Response to ASED-EM-0620-04 on LOU baffling
B. Swinyard

The analysis presented in HP-2-ASED-TN-0023 iss 3 deals, as far as I can tell, with straylight from the LOU windows for three cases:

Ref: SPIRE-RAL-NOT-002128

Figure 1: Extract from Cryostat Study final report from 2000 showing that industry accepted the need for an LOU baffle and that there was a notional design for it.

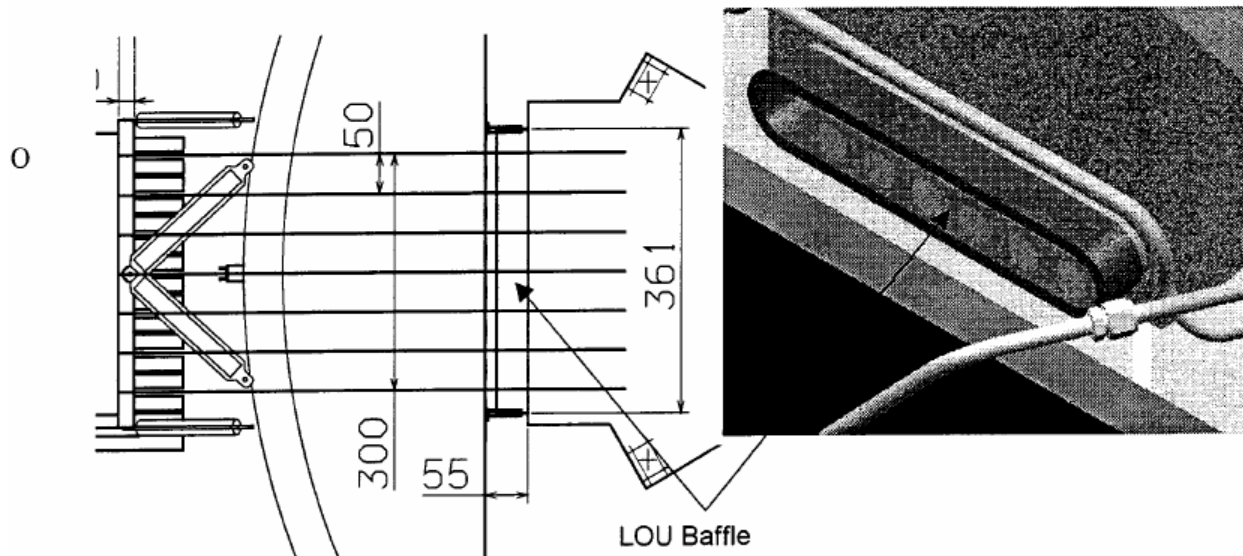
The third item here is discussed in section 5.2 of the report but the results are not explicitly given for this path (see table 1) hence my confusion in the previous issue of this note. On the basis of this analysis it seems that no baffle is provided on the inside of the instrument shield to prevent straylight from the LOU holes reaching PACS and SPIRE – this is despite our explicit request for such a shield and its inclusion in the original cryostat study – see figure 1.

Figure 2: Sketch of design for LOU baffling from Astrium – the instrument shield baffle has gone missing – the red lines indicate where the baffle must be placed to minimise the straylight into the instrument shield. Also missing is any treatment from the 34-K environment indicated by the wavy line.

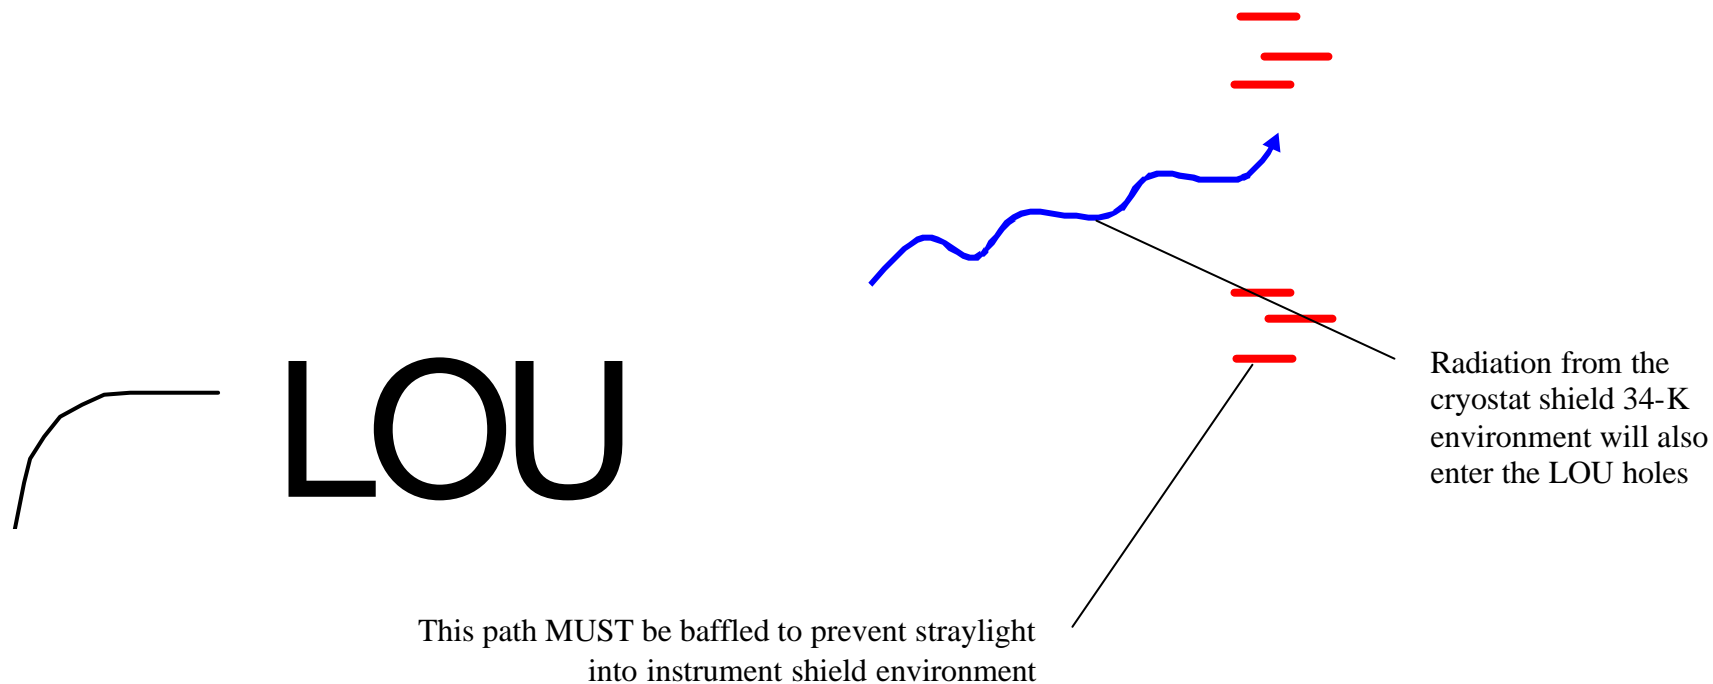
All these concerns lead us to the question: “where has the LOU inner shield baffle it gone?” The CDR “design” no longer appears to show this baffle. This is completely unacceptable and SPIRE rejects this design forthwith. We indicate on the sketch provided an indication of where the baffle must be located in order to prevent unwanted radiation entering the instrument shield environment.
